From: [Glen Donaldson \(Place\)](#)
To: [James Stannard](#)
Cc: [Planning Comments \(HPBC\)](#)
Subject: HPK/2023/0499 - 39 Hopton Wood Way, Buxton
Date: 23 January 2024 11:41:28
Attachments: [image003.png](#)
[PL04_A_Hopton_Wood_Way.pdf](#)

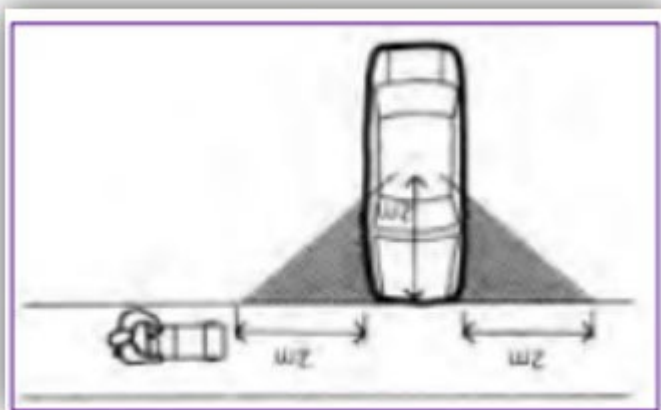
The applicant has provided an updated drawing PL04 (attached) which still has the wall height to be 2m and a blue line without any measurements, so for the avoidance of doubt, the pedestrian visibility splay should be provided on any new or widened private driveway in lieu of a bellmouth. This should take the form of a 2m x 2m triangle measured from the edge of the driveway and back of the footway or carriageway if no footway is provided. Nothing should exceed 600mm in height within this space and the design should maintain this position (see example below).
